### REQUEST FOR INFORMATION FORM

RFI # 009  
Date 10/04/24  
Date Needed By: 10/04/24

Proj.: **Court St. Community Center Repairs**  
122 Court St.  
Bay St. Louis, MS 39520

##### GLASS PANELS

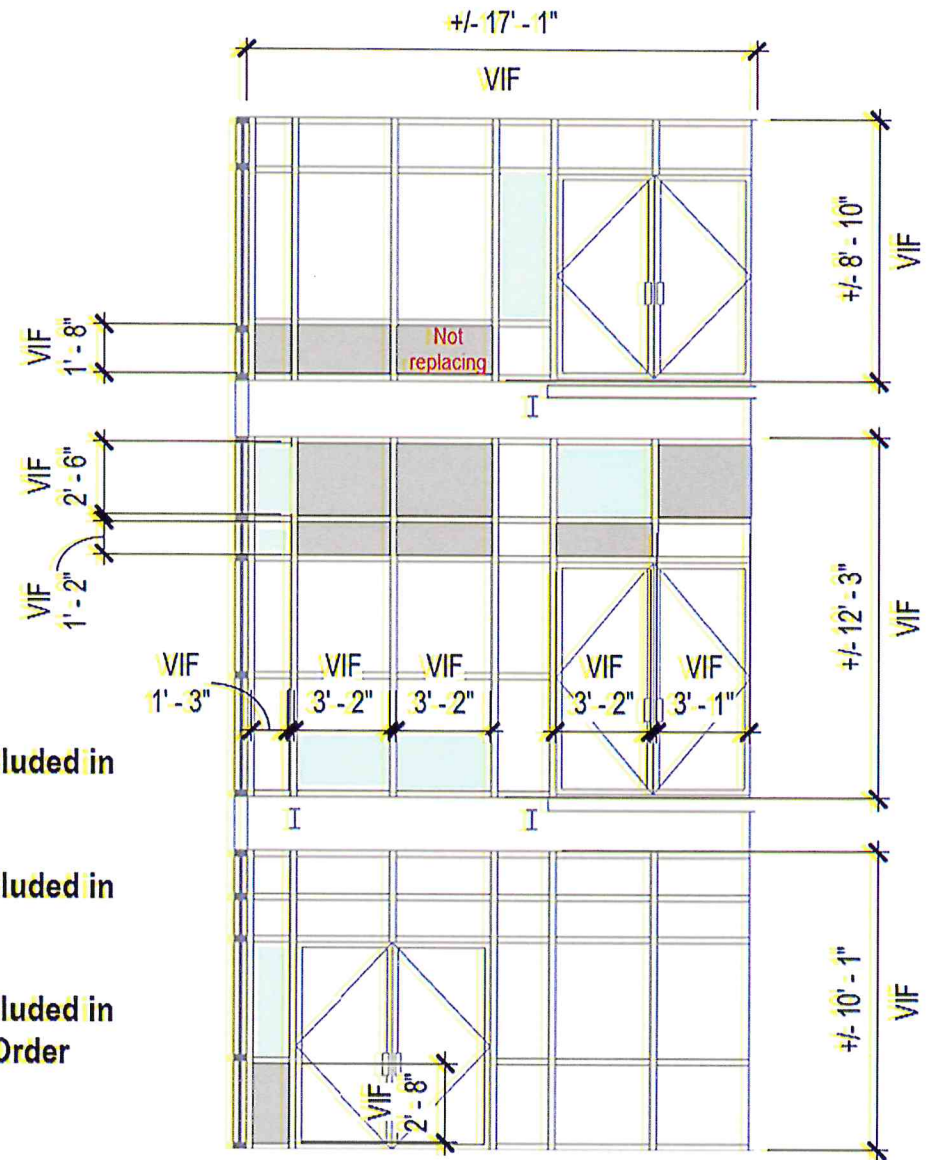
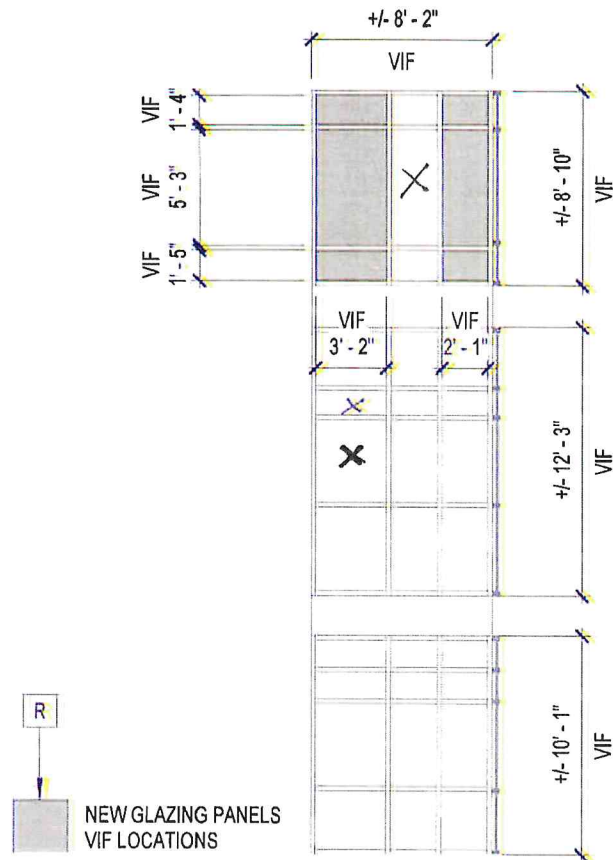
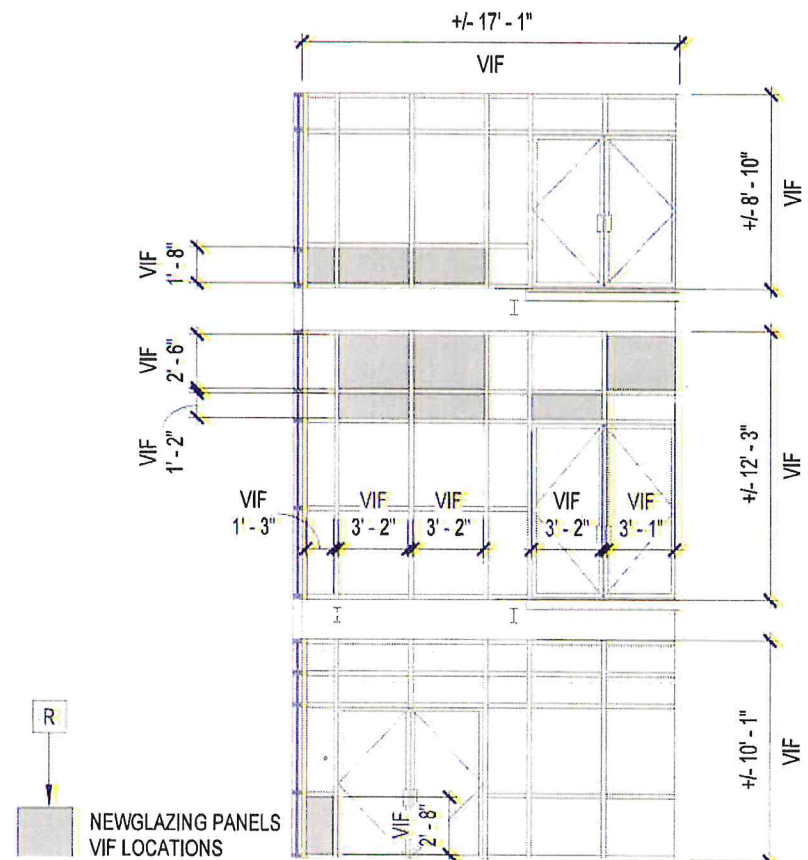
The Glass Company, while working on the curtain elevations discovered three pieces of glass that needed to be replaced due to water intrusion from failed seal.

Please advise.

Note: See attached Change Order Request from the Subcontractor and marked elevation page for reference.

TO REPLACE 3 ADDITIONAL PIECES OF GLASS DUE TO WATER INTRUSION FROM FAILED SEAL. GLASS IS TO BE SOLARBAN 60 OVER CLEAR 1 5/16" IMPACT RATED GLASS UNITS TO MATCH SURROUNDING UNITS.

NOTE: PLEASE SEE MARKED ELEVATION PAGE TO SHOW WHICH PIECES ARE TO BE REPLACED.

- New glazing panels included in Alternate #1
- New glazing panels included in Change Order #3
- New glazing panels included in the proposed Change Order

*X - Failed units found*
